# Access Compliance Report Public Rights-of-Way (Curb Ramps)

| Main Street: W_HARRIET_LN               |                                  | Cross Street: BROOKHURST_ST |                                         | Location:       | SE |
| ADA ID: RPAT220202145600                | Ramp Type:Type 1 - Perpendicular | Initial Pass/Fail: Fail     | Overall Compliance: No                  | Severity Score: | 19 |

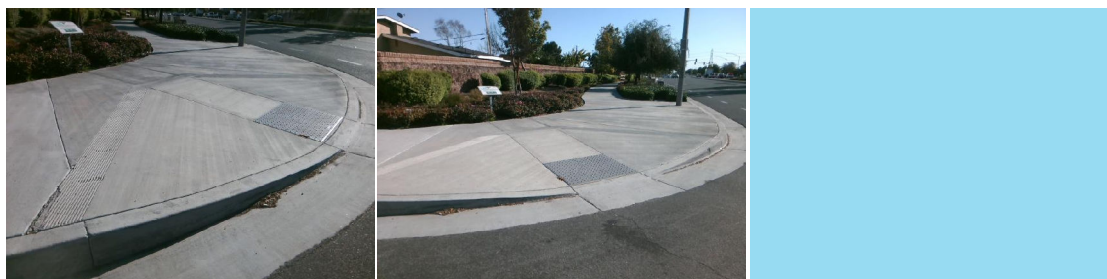
R304.2.2, R304.5.1, STD 1115

| Compliance | Description                           | Data | Compliance | Description                   | Data |
|------------|---------------------------------------|------|------------|-------------------------------|------|
| No         | Ramp Width (in)                       | 47   |            |                               | N/A  |
| No         | Ramp Run Slope (%)                    | 8.7  | N/A        | Flare Slope LT (%)            | N/A  |

Remove & Replace Entire Ramp.
